MORGAN OFFSHORE WIND PROJECT: GENERATION ASSETS

Technical engagement plan appendices part 3 (Appendix C)

Document Number: MRCNS-J3303-RPS-10028

Appendix C: Evidence Plan Marine mammals EWG

Annex 1 – Map of Survey Stations for the PELTIC survey

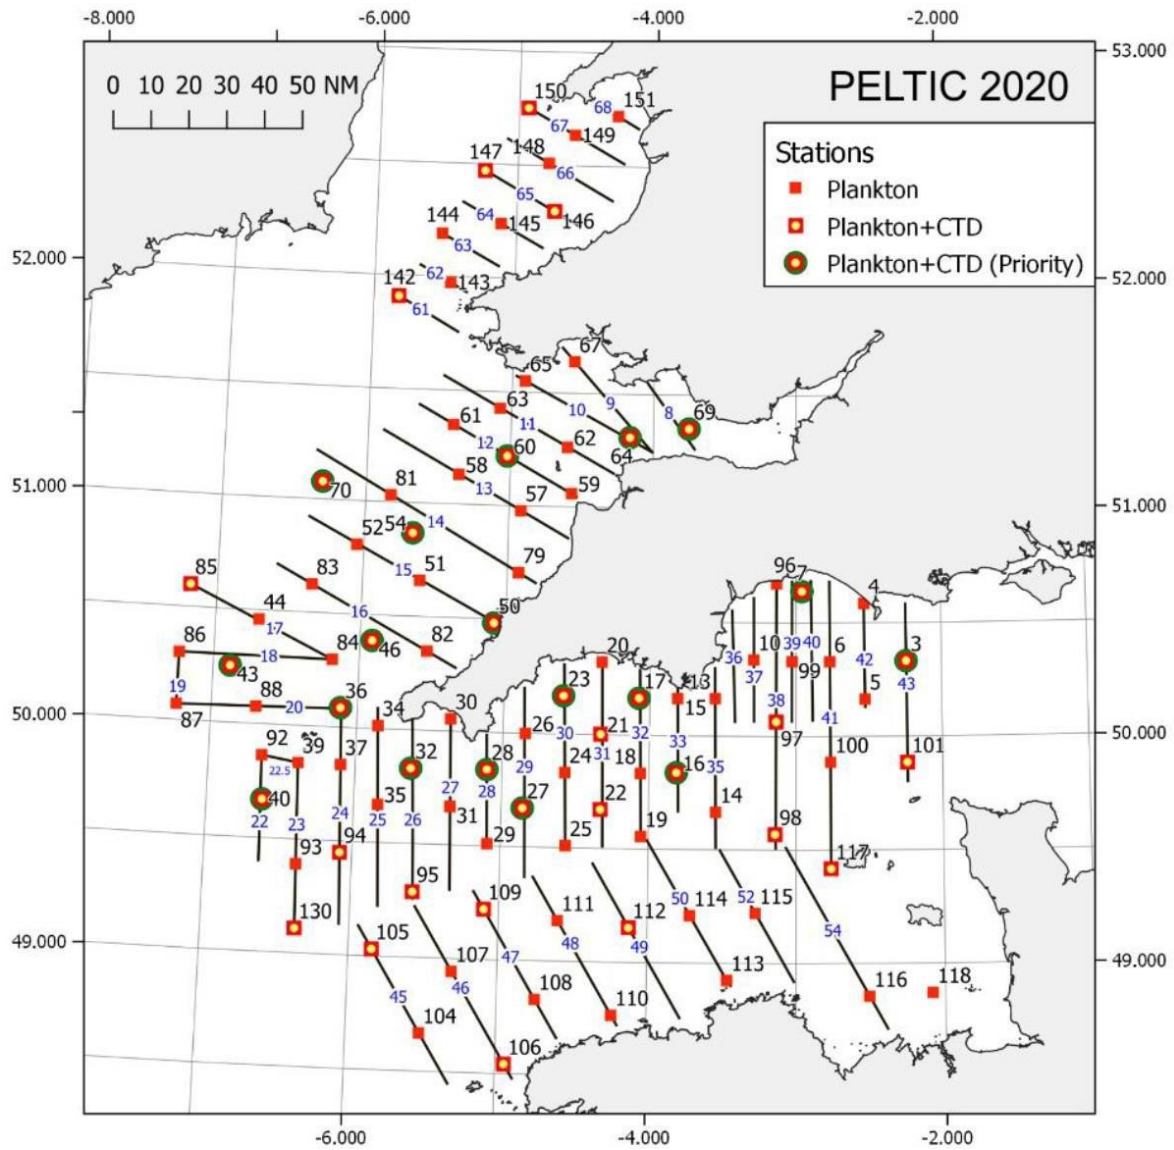
6. During the expert topic meeting reference was made to the Cefas Pelagic ecosystem survey in the Western Channel and Celtic Sea (PELTIC) surveys and their potential use as a source of information/data to inform the baseline for fisheries. The MMO would advise that in the Irish sea the survey stations only go as far north as Llŷn Peninsula in North Wales, which is significantly further south of the proposed locations for Morgan and Mona. The day may be useful to provide broadscale information and data on pelagic species in the Irish Sea but may not be as useful for providing site-specific fisheries data for the windfarm study areas. See Annex1 for map of PELTIC survey stations.

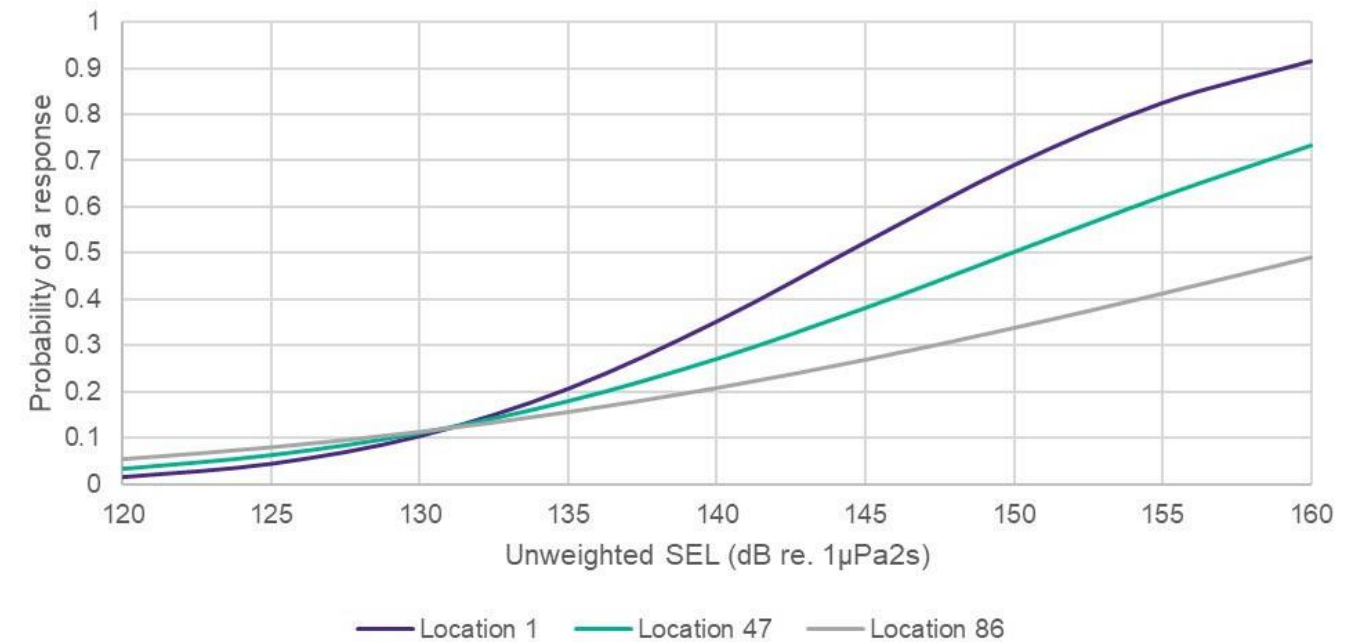
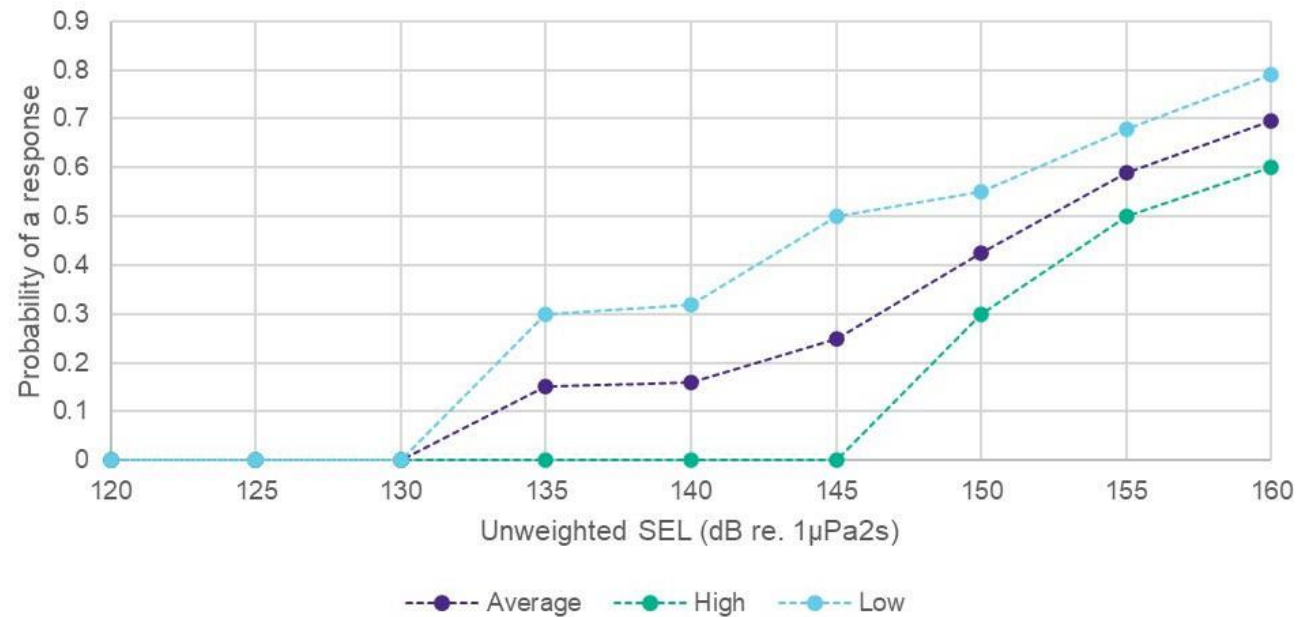
- With reference to *Section 1.3.2.7 Marine Mammals*, NRW (A) would not recommend applying a dose-response curve developed for harbour porpoise to all cetacean species when carrying out an EIA to assess the number of animals that would be disturbed by piling. Whilst NRW (A) acknowledge the precautionary approach taken, this will likely lead to overestimates for species in different hearing groups. The applicant should either justify this approach in detail (with reference to published material) or preferably specify a method used to assess disturbance for cetaceans other than harbour porpoise, i.e. bottlenose dolphin, minke whale, Risso's dolphin, common dolphin and white-beaked dolphin (as listed in *Table 1.3: Assessment swim speeds of marine mammals and fish that are likely to occur within the Irish Sea for the purpose of exposure modelling*). Possible options for bottlenose dolphin, for example, could include US level B harassment levels (NMFS, 2005), or thresholds based on previous studies e.g. single-strike SEL of 129-133 dB re 1 μ Pa²s (Graham *et al.*, 2017), or single-strike SEL 128 dB re 1 μ Pa²s (Fernandez-Betelu *et al.*, 2021).

- NRW (A) note the proposal to use the dose-response curve in Russell *et al.*, (2016) developed for harbour seal as a proxy for grey seal. Whilst we are satisfied with the approach proposed, NRW (A) recommend that the applicant provides further information to validate this approach, referencing published materials demonstrating similar behavioural reactions to pile driving between grey seal and harbour seal (e.g. Gotz & Janik, 2010; Aarts *et al.*, 2018).

Three dose-response curves have been presented on Figure 1.1 for harbour porpoise. Similarly, in Figure 1.2, three dose-response curves are presented, termed “average”, “high” and “low” for seals.

- We request clarification on how the three dose-response curves will be used.
